66KV DOUBLE BUSBAR GIS SWITCHGEAR HT-9311

PROJECT: CAPTIVE POWER PLANT (CPP) PACKAGE VISAKH REFINERY MODERNIZATION PROJECT (VRMP) JOB NO. B016				
OWNER: HINDUSTAN PETROLEUM CORPORATION LIMITED				
PMC: ENGINEERS INDIA LIMITED (EIL), NEW DELHI				
BHARAT HEAVY ELECTRICALS LTD. HYDERABAD				
NAME		SIGN.	DATE	NO.OF VAR.
DRN.	PK		19.04.18	
CHD.	DKS/AA		19.04.18	
APPD.	SKS/VK		19.04.18	
DEPT. TBG CODE: 450	UNTO. DIMS. 5/M/F	SCALE -N.A.-	WEIGHT (KG) -N.A.-	REF. TO ASSY. DRG. -N.A.-
TITLE: SINGLE LINE DIAGRAM FOR 66KV GIS		CARD CODE N.A.	BHEL DRG NO. TB-1-402-500-001	REV. 00
SHT. No 01		NO. OF SHT. 03

COMMENT SHEET

SL. NO.	COMMENT/ OBSERVATION	RESOLUTION / ACTION
1	DRAWING / DOCUMENT TITLE : SINGLE LINE DIAGRAM FOR 66KV GIS DOCUMENT NUMBER: TB-1-402-500-001 R 00 CATEGORY/CODE: 2

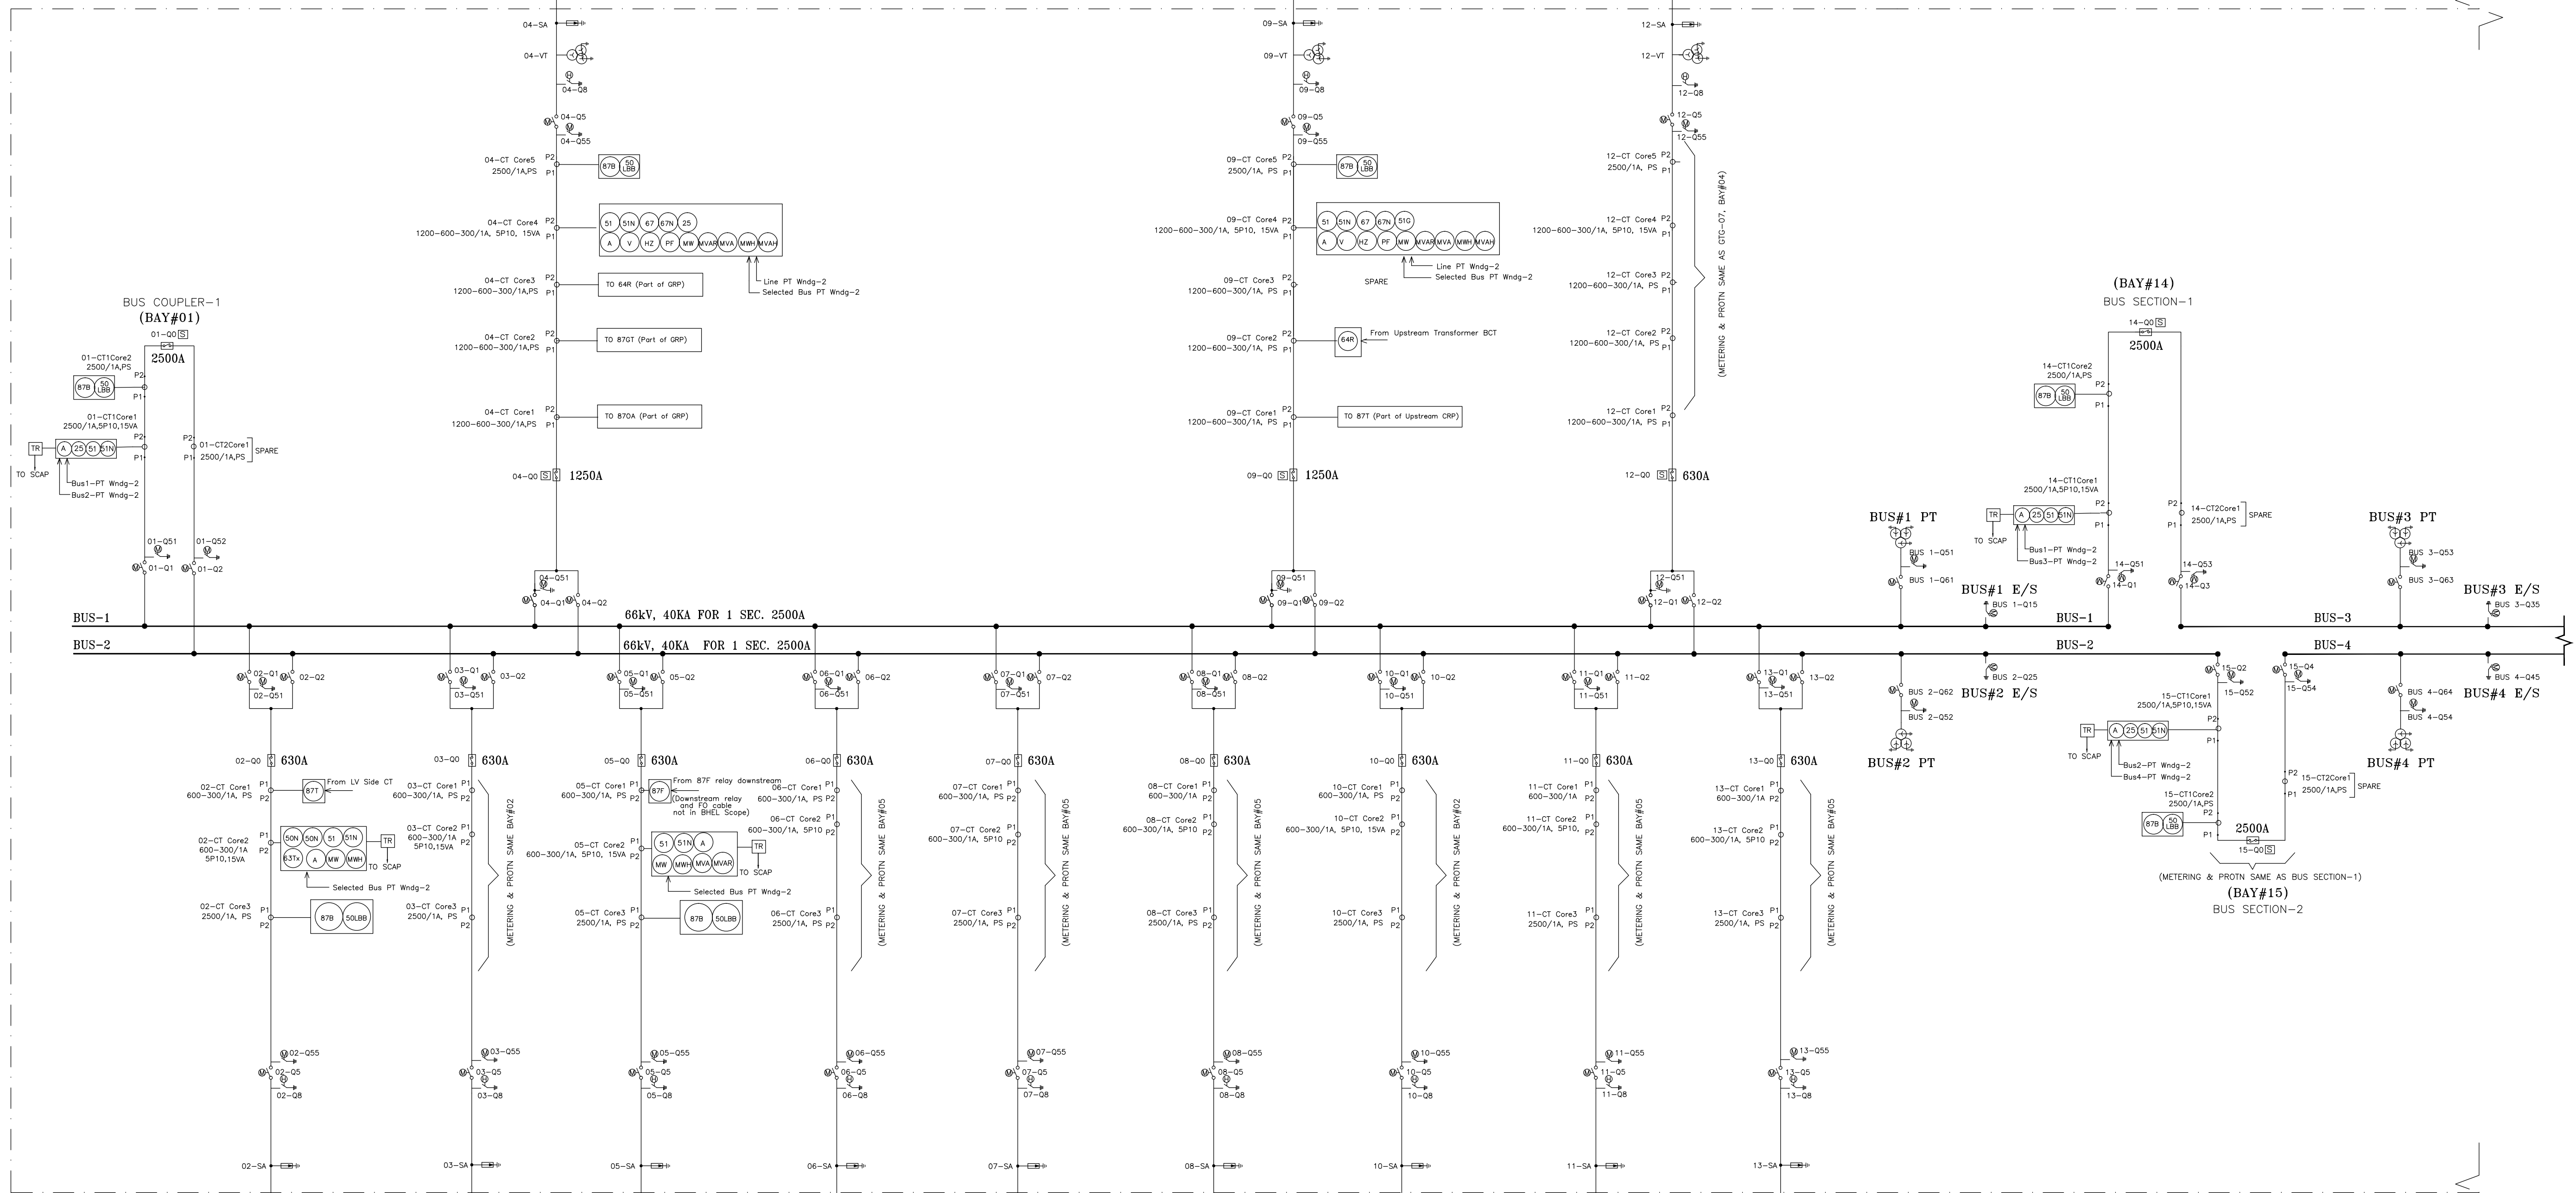
1.	Show capacitive voltage detectors in each feeder / incomer	
2.	Include a note indicating the components mounted in CRP.	
3.	Please clarify whether transducers for SCAP and ECS will be part of CRP. Incase yes, indicate the transducers in CT circuit.

4.	Spare CT indicated in bus coupler / bus sectionaliser shall be indicated as differential CT. The same shall be connected to differential relays in other bus section to form overlapping zone.

5.	Indicate the current ratings of disconnecter switches.	
6.	PT symbol in the SLD and the legend are not matching. Please maintain uniformity.	
7.	Indicate knee point voltage of Class-PS CTs.

8.	Indicate parameters of Line PTs & Bus PTs	
9.	Please check and correct the moving arm of the disconnectors (for eg 04-Q1 & 04-Q2 etc)	
10.	Please clarify whether high impedance type differential protection or low impedance type differential protection is used. Include a note in the SLD. In case of low impedance differential protection, the representation of bay units of differential relay shall be clearly indicated in each feeder along with the main relay at central location for each bus.

11.	Each bus shall have separate differential relay.	
12.	Indicate protection elements 51V, 86 & 95 in all numerical relays.	
13.	Indicate protection element 25 in grid transformer incomers.

14.	Spare feeder Bay#03 shall be similar to Bay#05. Update the details	
15.	Please note that all outgoing feeders for Owner's substations are plant feeders. However the downstream transformer numbers are indicated for ease of reference in the SLD. Please update the description as below Bay#07- SS-84 TR-8403 (RUF) Bay#13- SS-90 TR-9001 (HGU) Bay#26- SS-84 TR-8404 (RUF) Bay#23- SS-90 TR-9002 (HGU)

16.	Stabilizing resistors and metrosils shall be provided for numerical relays to prevent any spurious tripping. Add a note regarding the same.	
17.	Also refer comments on CT PT sizing calculation document.
